**DESIGN REVIEW
REC PROPOSAL
300 W Republican Street
Seattle, WA 98119**

NEW MULTIFAMILY BUILDING | KOZ DEVELOPMENT

**SDCI # 3036974-EG
West Design Review Board
Meeting Packet for 2/16/22**

Response to EDG/DRB 1 Comments

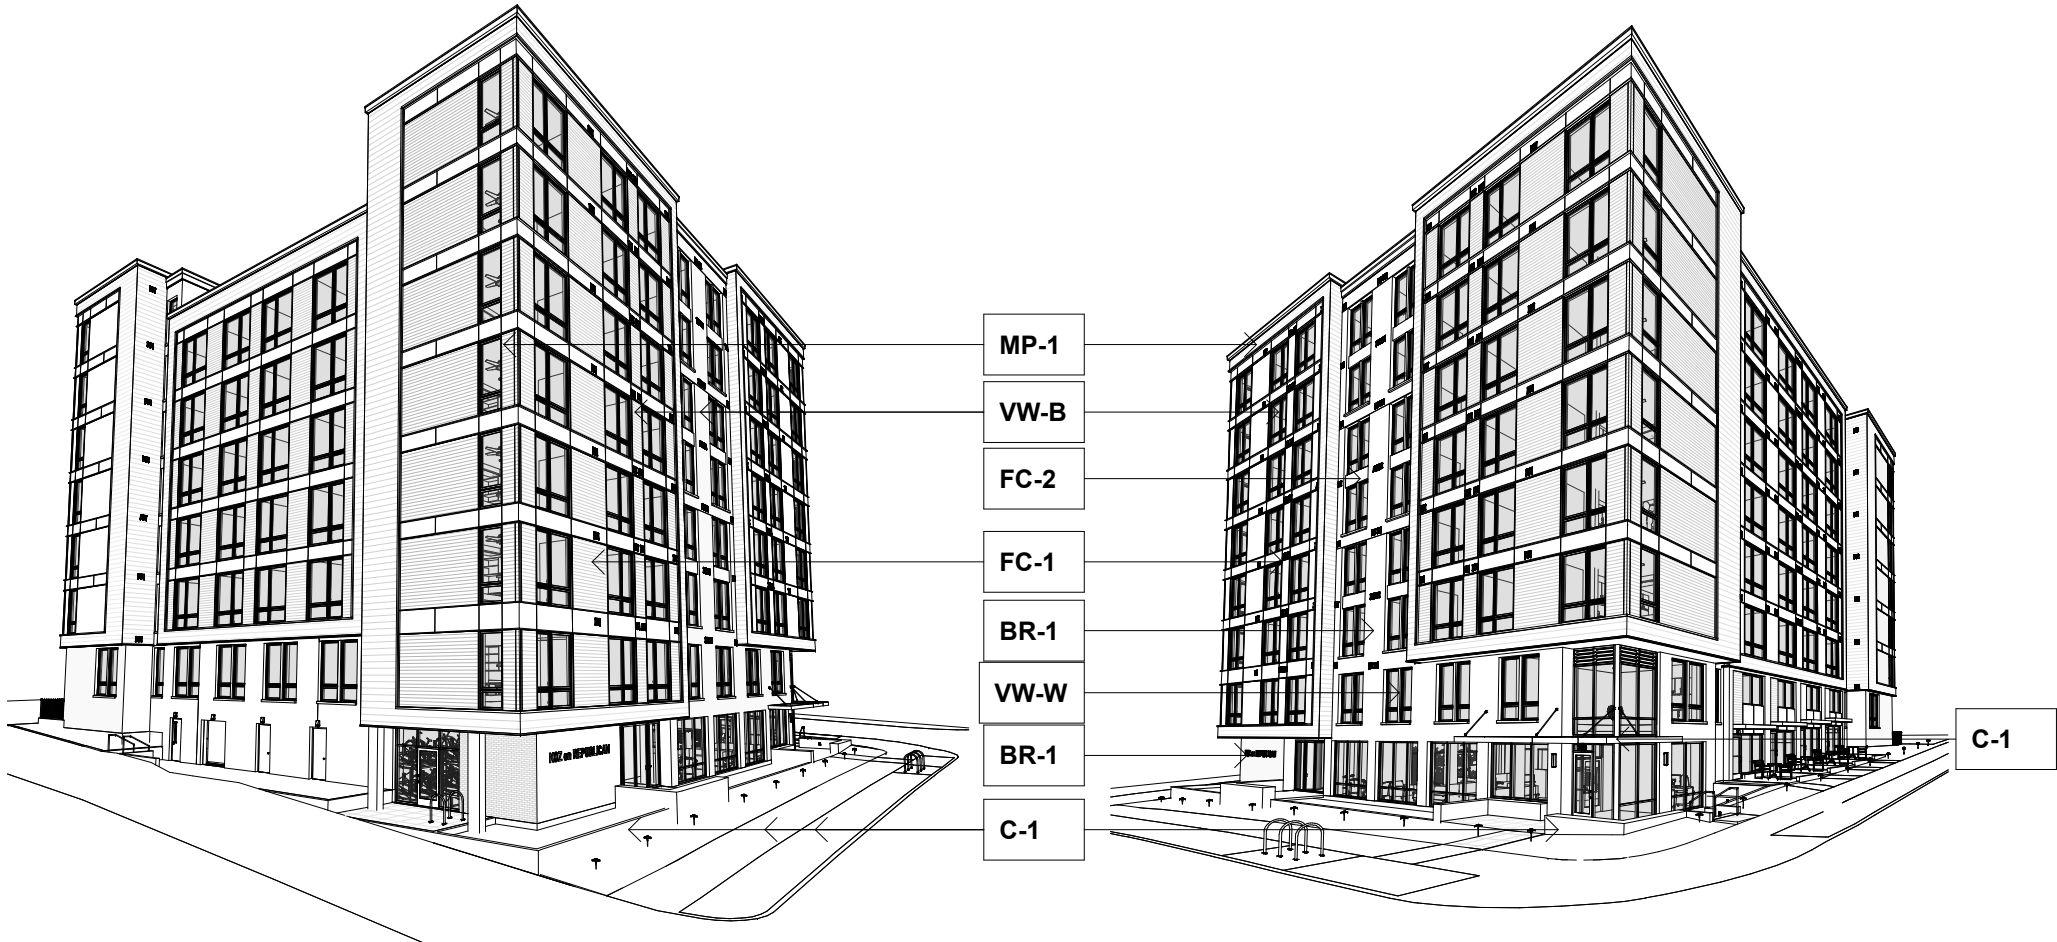
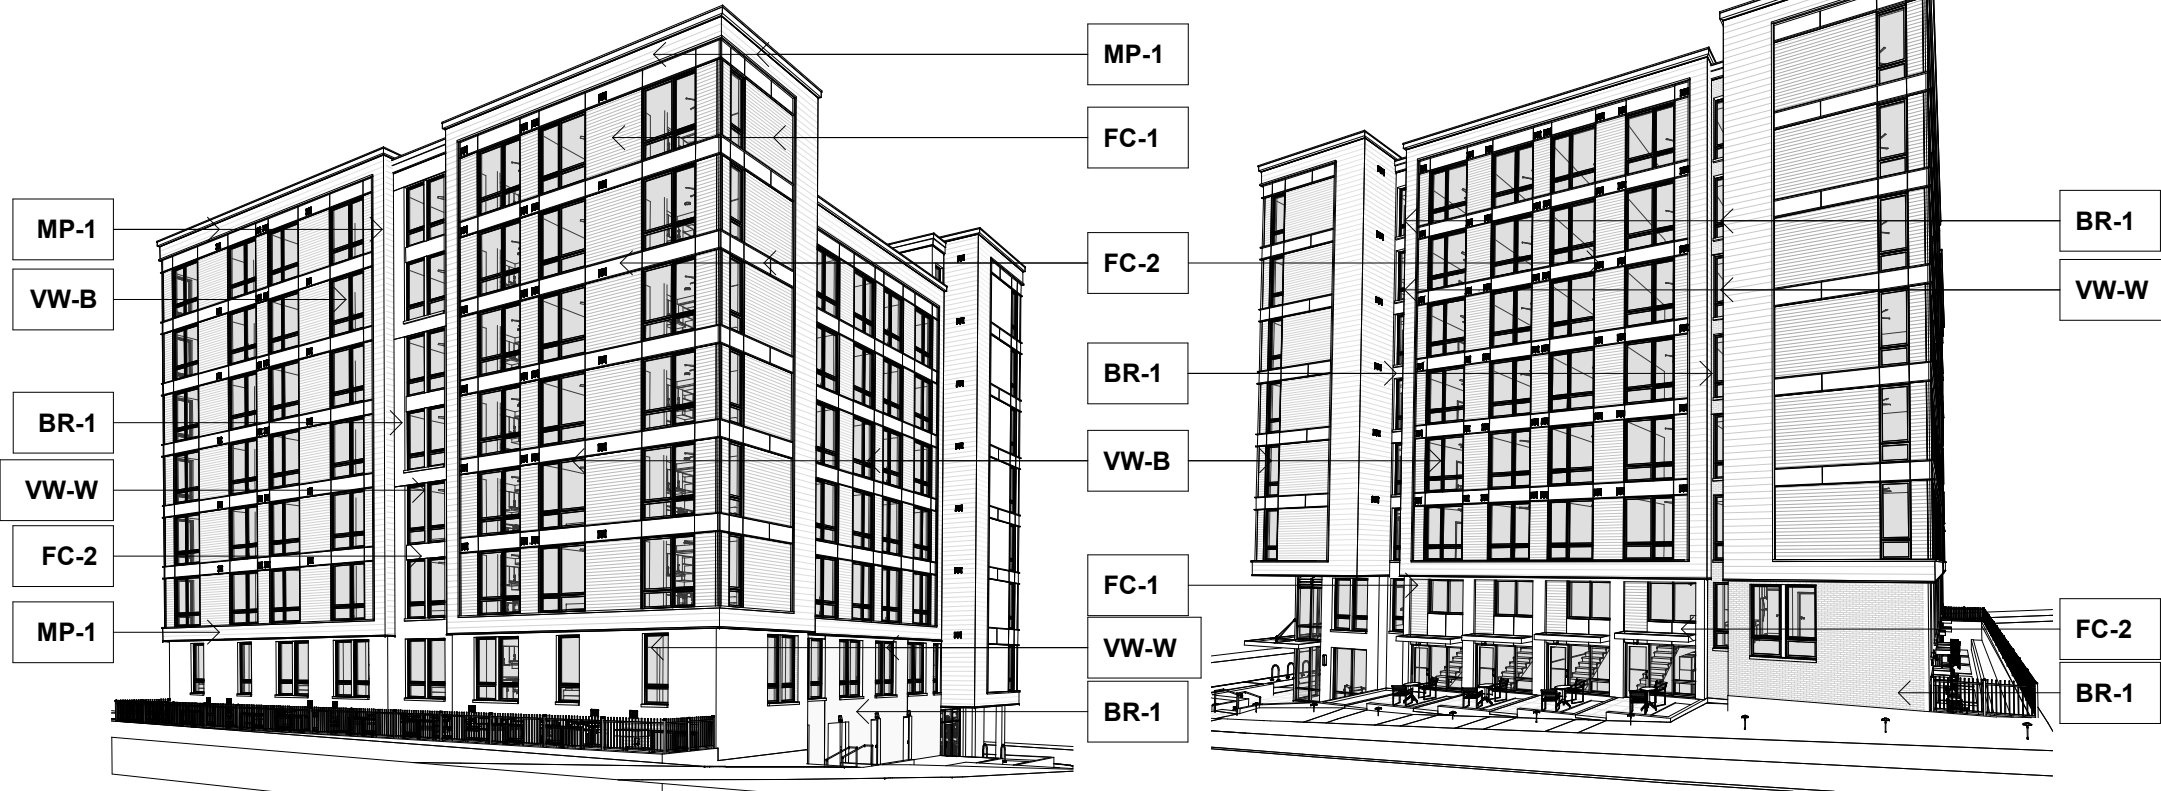
c.) The Board directed further development of a high-quality material palette and fenestration pattern that creates depth and texture, and wraps all facades for a consistent overall architectural expression. In response to public comment, the Board supported the proposed use of brick and metal panel, and specifically prioritized Uptown Design Guideline DC4-1, Building Materials. (DC2-B-1, DC4-A, DC4-1).

Fiber Cement Panels
Flat Smooth Panel
- MP-1

Metal Panel
3" Horizontal Rib
- BR-1

Brick
Common Running Bond
- C-1

Concrete
Boardform Decorative
- VW-W

① Parapet Coping @ Metal Siding
1 1/2" = 1'-0"

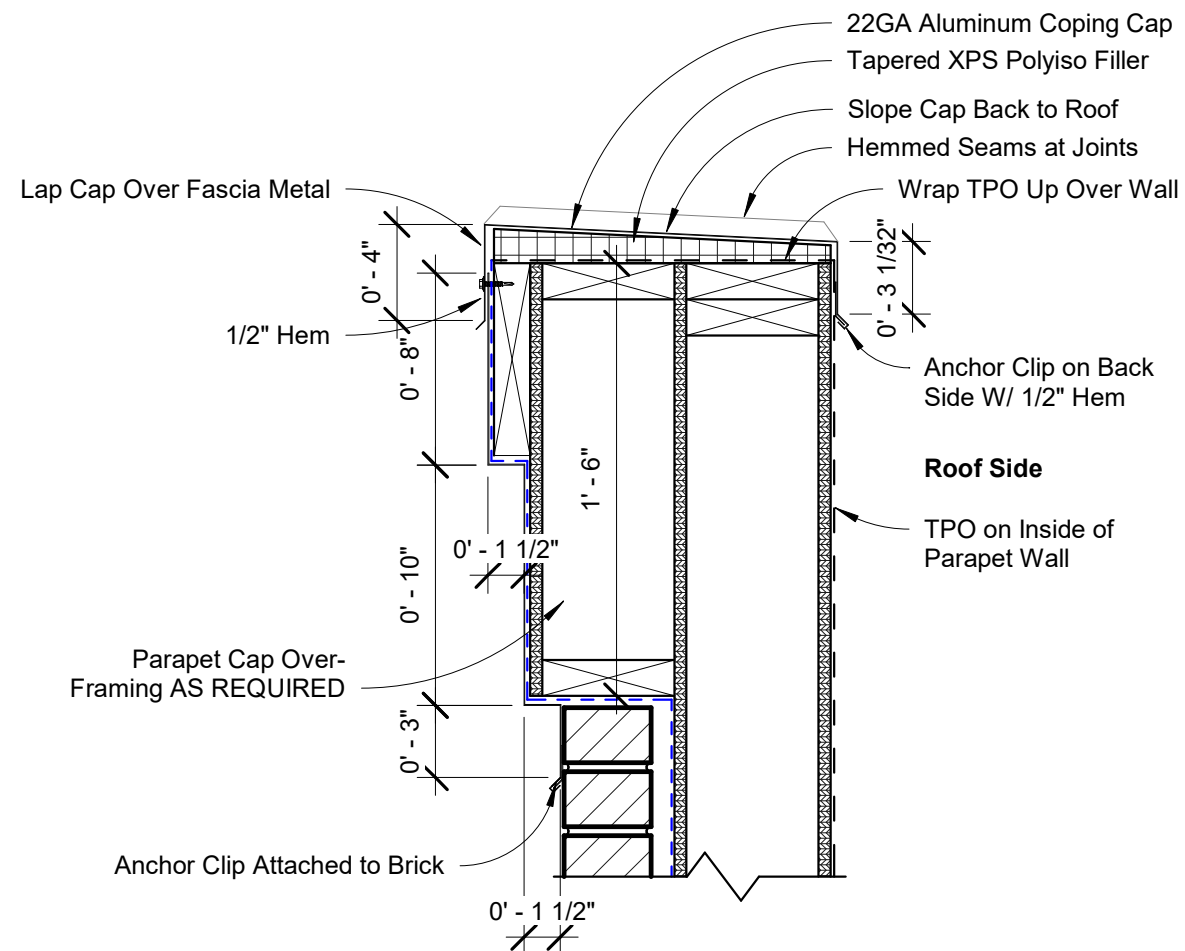
d.) The Board noted that the strength of the architectural expression will depend on high-quality detailing, and requested that material details be provided in the Recommendation packet. (DC2-B-1, DC4-A, DC4-1)

1 Brick Window Details
1 1/2" = 1'-0"

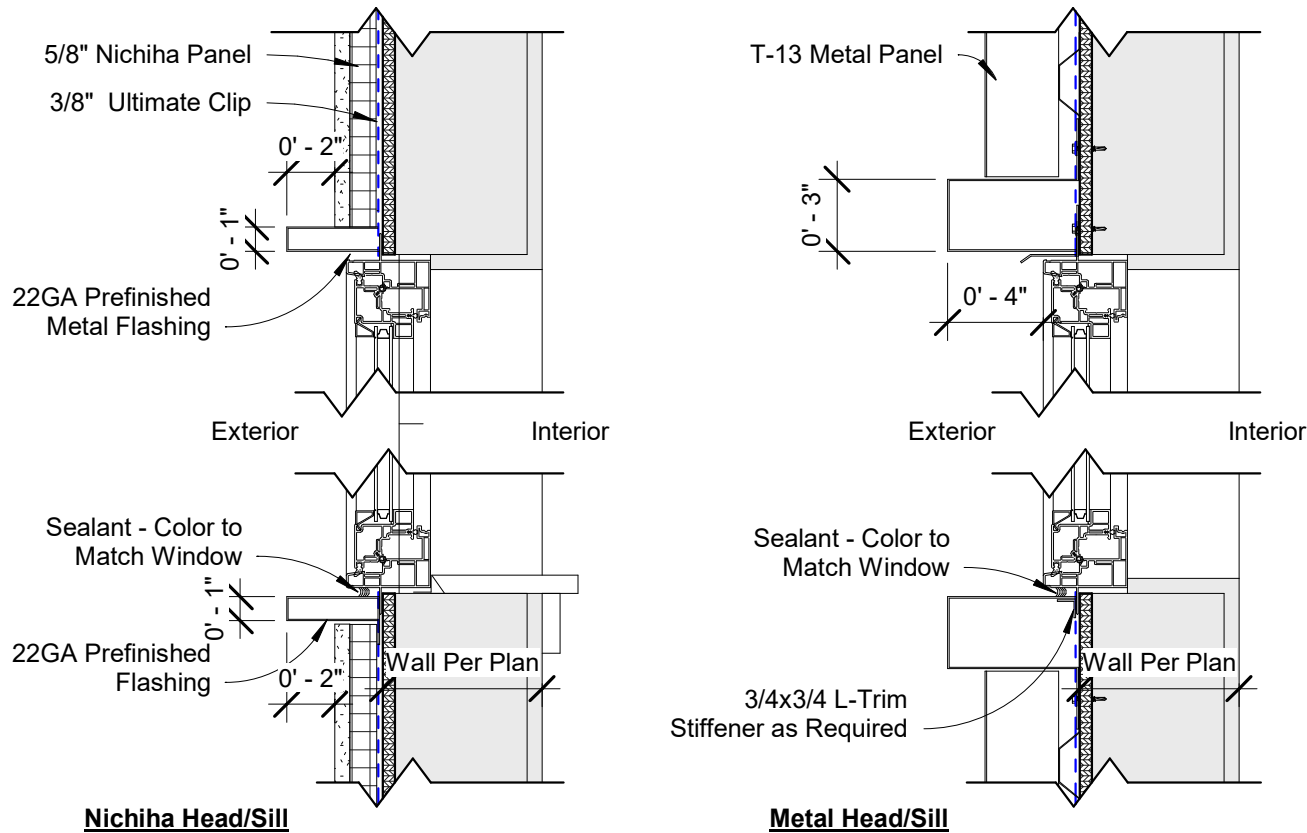
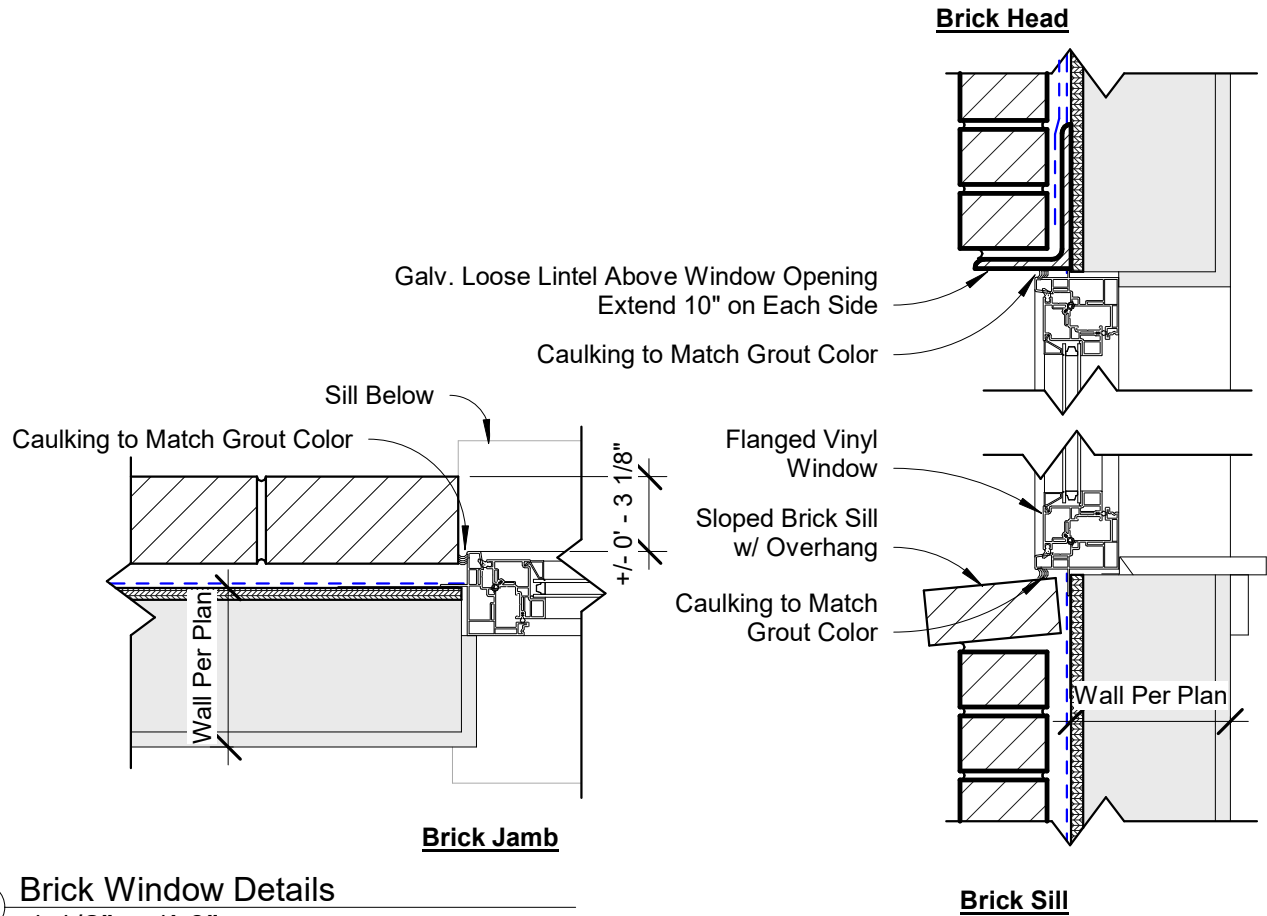
e.) The Board specifically prioritized Uptown Design Guideline DC2-3-b, Window Design, which encourages “substantial window detailing and recessed windows” and discourages “flush window treatments”. (DC2-3-b)

Window detailing has been provided on the following sheets to illustrate design intent, depth, and treatment of the cladding around the windows. Flanged vinyl windows are proposed for cost effectiveness, durability, and ease of waterproofing. The typical window area/size has been maximized based on the north elevation proximity to the property line which allows a maximum 45% unprotected opening with a 10’ minimum setback to the structure. Windows have been standardized for a consistent architectural language around the building on each façade. The proposed design uses the exterior cladding materials to create depth, rhythm, and an architectural language around the grouping of the exterior fenestration. The composition of the windows and patterning changes are based on the façade cladding, primarily between the brick and metal but also at the lower level grade units with patios. Nichiha panels are used as an accent in both the metal portions of the façade and the brick. Metal trim and brick provide a deeper reveal (between 3-4”), while the Nichiha panel intentionally has the window +/-1/2” proud of the exterior surface. The difference in depth between materials creates a language and pattern in the façade that helps reinforce variation in planes without complicated and wasteful over-framing. While the design guidelines “discourages” flush window treatments, the 1/2” reveal using the Nichiha is sparingly used and is used very deliberately for effect and an emphasis on depth around the windows.

1 Republican St Arch Landscape Plan
1" = 10'-0"

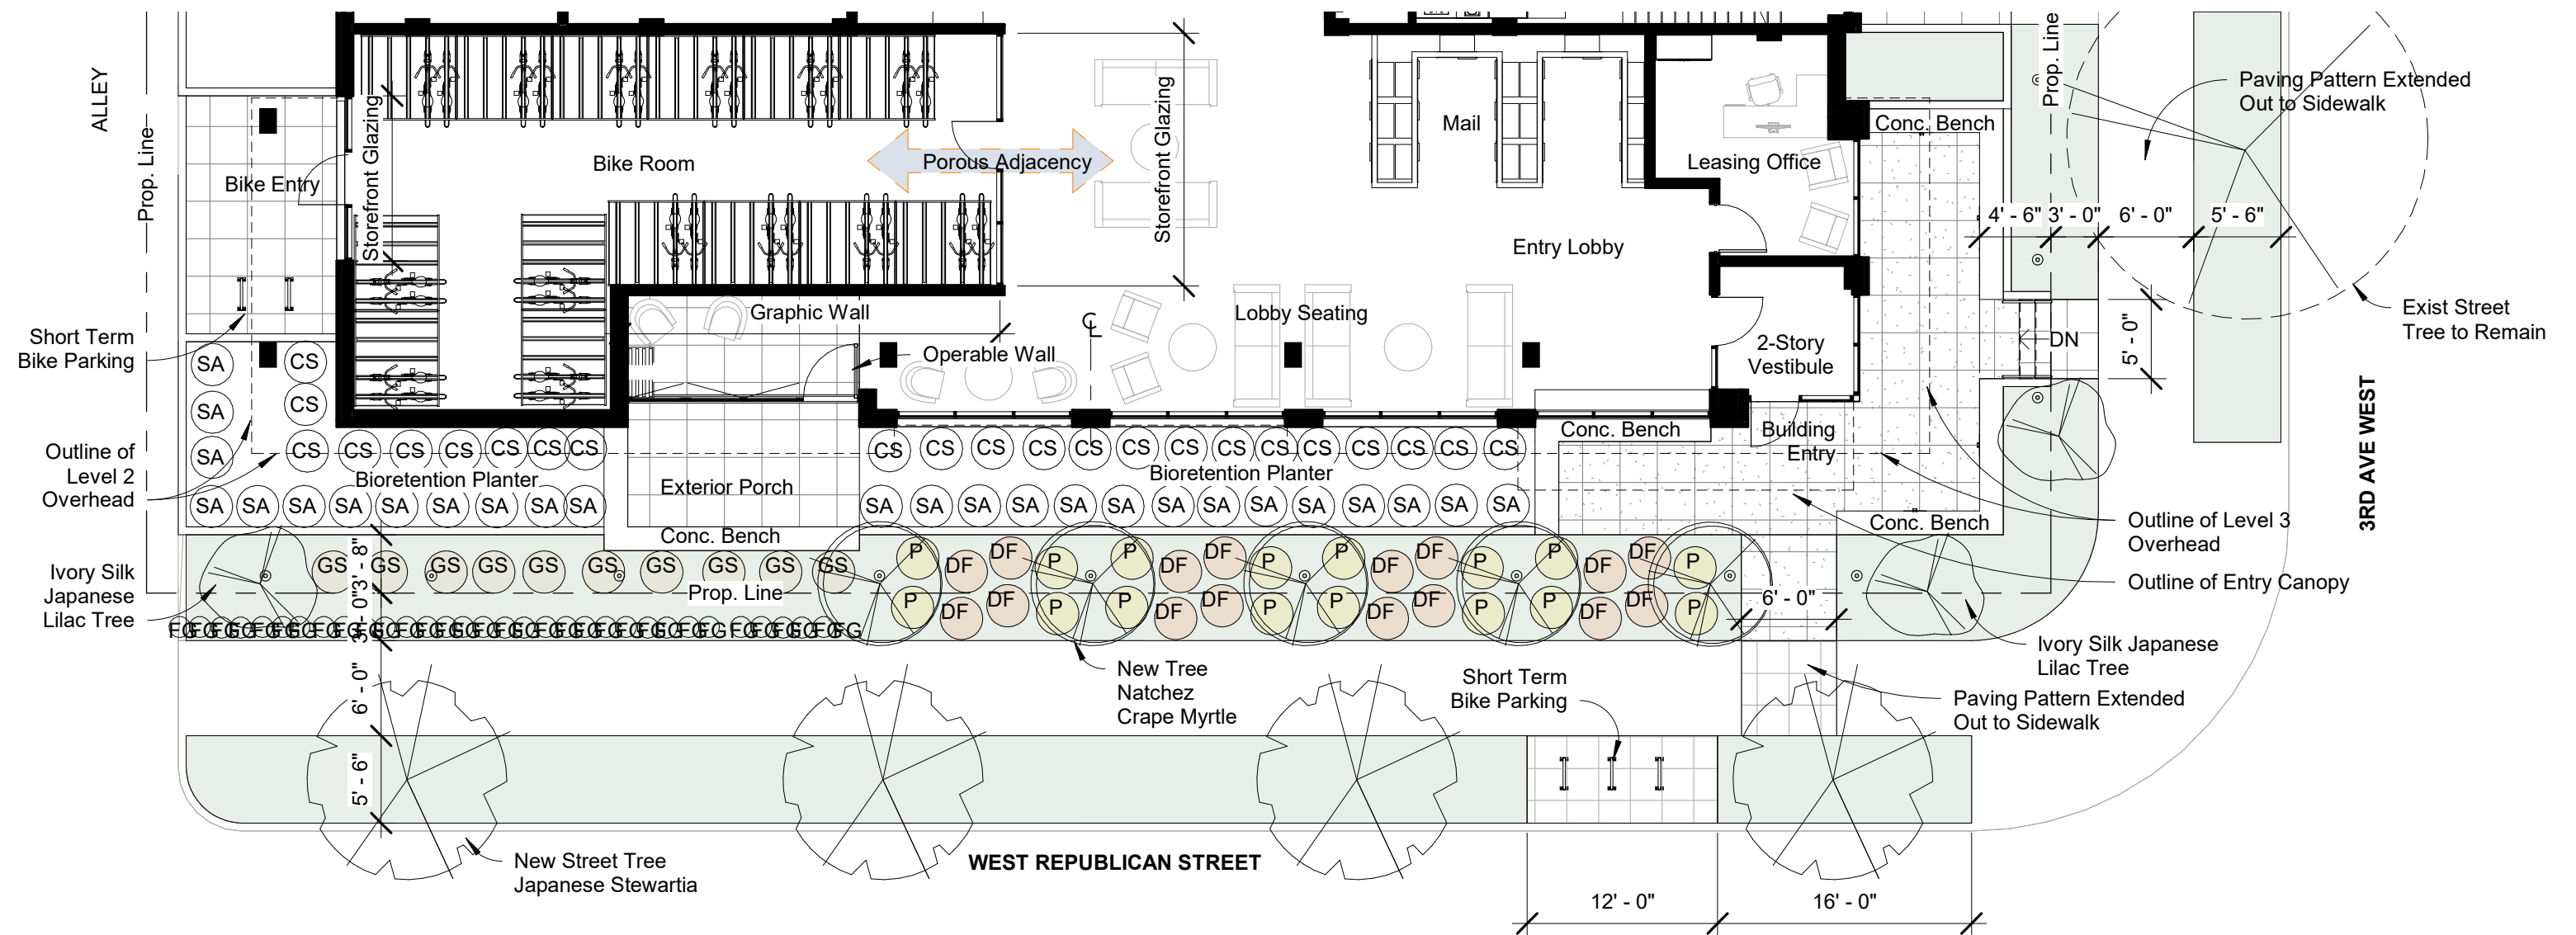
- i. The Board questioned the rationale of closing the corner entry and placing barriers at the exterior space. They noted that fences are the opposite of what the Design Guidelines are trying to achieve along the streetscape edges, and recommended the design be modified to resolve this concern. **CS2-3 Corner Sites, CS2-B-2. Connection to the Street**
- ii. In response to public comments related to the enclosed patio, the Board recommended that the applicant to revise the landscape design to bring it closer to the design intent of the accessible corner courtyard presented at EDG. They noted that an integrated ADA accessible walk access, a semi-public exterior gathering area, and integration with active building uses, should be studied. The Board specifically prioritized Uptown Design Guidelines

The corner patio has been largely removed and revised to become a semi-public entry court and is now a space of transition without barriers to the public. A 2-story glass entry vestibule has been added for clear definition of the main building entry. Paving patterns at the entry have been extended out through the sidewalk to create interest and interaction with the public ROW. Seating areas have been added along the Republican Street sidewalk with adjacency to the generous storefront glazing at the lower-level lobby.
